Draft Amendment to Regulation No. 117

PROPOSAL TO ADD TYRE ADHESION PERFORMANCES TO UNECE REGULATION No. 117
Document TRANS/WP.29/GRRF/2005/11/Rev.1

Example 1.

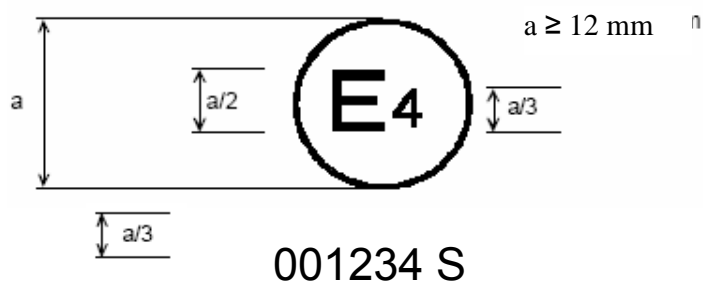
The above approval mark, affixed to a pneumatic tyre shows that a tyre concerned has been approved in the Netherlands (E4) pursuant to Regulation No. 117 (marked by S (rolling sound) only), under approval number 001234. The first two digits of the approval number (00) indicate that the approval was granted according to the requirements of this Regulation in its original form.

Example 2,

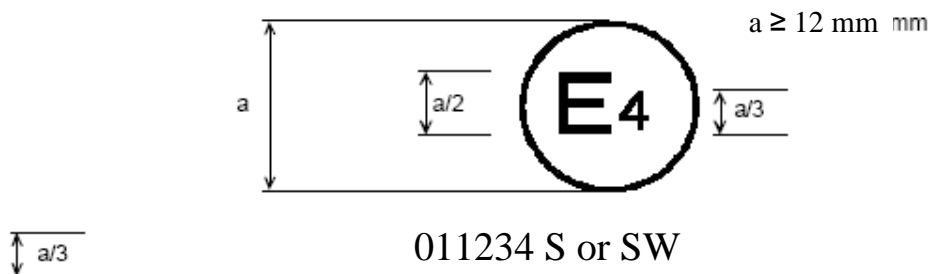
The above approval mark shows that the tyre concerned has been approved in the Netherlands (E4) pursuant to Regulation No. 117 (marked by S (rolling sound) or both S (rolling sound) and W (wet adhesion), under approval number 011234. This indicates that the approval is for S or both SW. The first two digits of the approval number (01) indicate that the approval was granted according to the 01 series of amendments.

Example 1

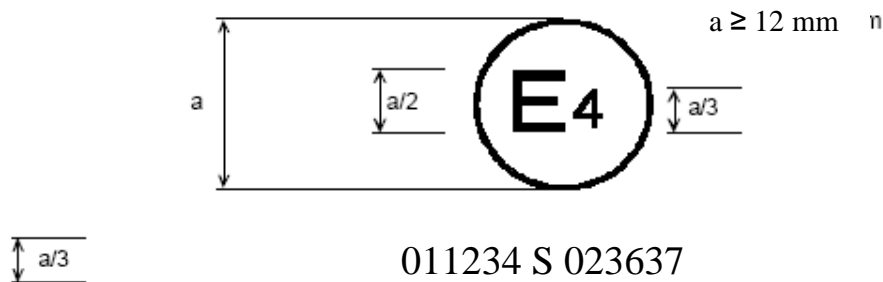
The above approval mark shows that the tyre concerned has been approved in the Netherlands (E4) pursuant to Regulation No. 117 (marked by S (rolling sound), under approval number 011234 and Regulation 30 under approval number 023637. The first two digits of the approval number (01) indicate that the approval was granted according to the 01 series of amendments, but Regulation No. 30 included the 02 series of amendments.

Example 2

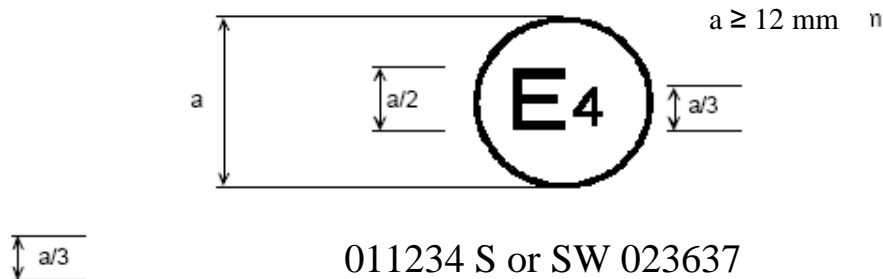
The above approval mark shows that the tyre concerned has been approved in the Netherlands (E4) pursuant to Regulation No. 117 (marked by S (rolling sound) or SW (rolling sound and wet adhesion), under approval number 011234 and Regulation 30 under approval number 023637. The first two digits of the approval number (01) indicate that the approval was granted according to the 01 series of amendments, but Regulation No. 30 included the 02 series of amendments.

Example 3

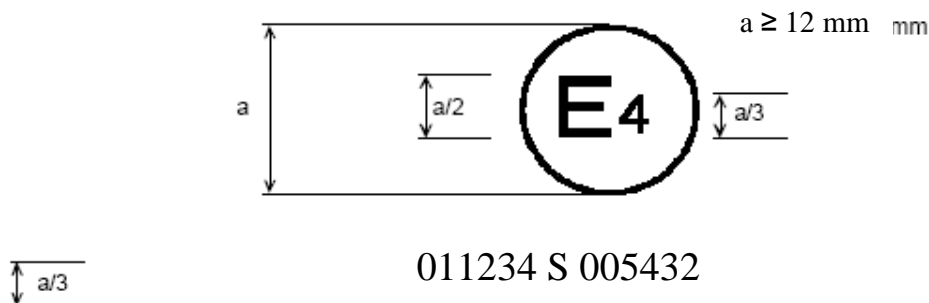
The above approval mark shows that the tyre concerned has been approved in the Netherlands (E4) pursuant to Regulation No. 117 and the 01 series of amendments under approval number 011234 (marked by S only), and Regulation No. 54. This indicates that the approval is for rolling sound (S) only, as Regulation 54 approved tyres at present cannot be approved for wet adhesion. The first two digits of the Regulation 117 approval number (01) in conjunction with 'S' indicate that the first approval was granted in accordance with Regulation 117 which included the 01 series of amendments. The first two digits of Regulation 54 (00) indicates that this Regulation was in its original form.

Example 1

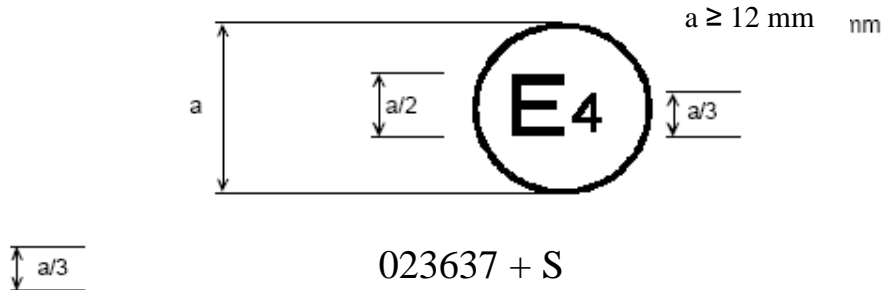
The above approval mark shows that the tyre concerned has been initially approved in the Netherlands (E4) pursuant to Regulation No. 30 and the 02 series of amendments under approval number 023637. It is also marked by + S (rolling sound) which indicates that its approval is extended under Regulation No. 117. The first two digits of the approval number (02) indicate that the approval was granted according to Regulation No. 30 which included the 02 series of amendments. The addition (+) sign indicates that the first approval was granted in accordance with Regulation No. 30 and has been extended to include Regulation No. 117 approval(s).

Example 2

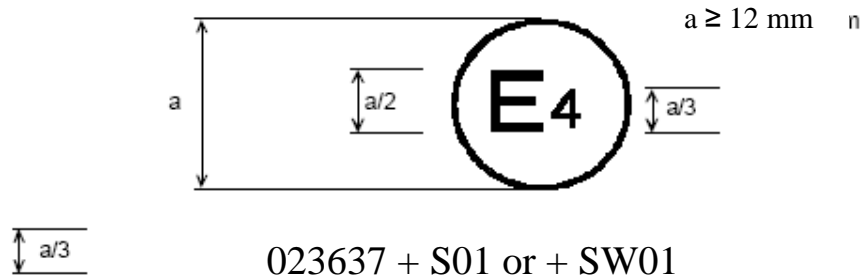
The above approval mark shows that the tyre concerned has been initially approved in the Netherlands (E4) pursuant to Regulation No. 30 and the 02 series of amendments under approval number 023637. This indicates that the approval is for S (rolling sound) or S (rolling sound) and W (wet adhesion). The S or SW followed by (01) indicates that it has had its approval extended under Regulation No. 117 which included the 01 series of amendments. The first two digits of the approval number (02) indicate that the approval was granted according to Regulation No. 30 which included the 02 series of amendments. The addition (+) sign indicates that the first approval was granted in accordance with Regulation No. 30 and has been extended to include Regulation No. 117 approval(s).
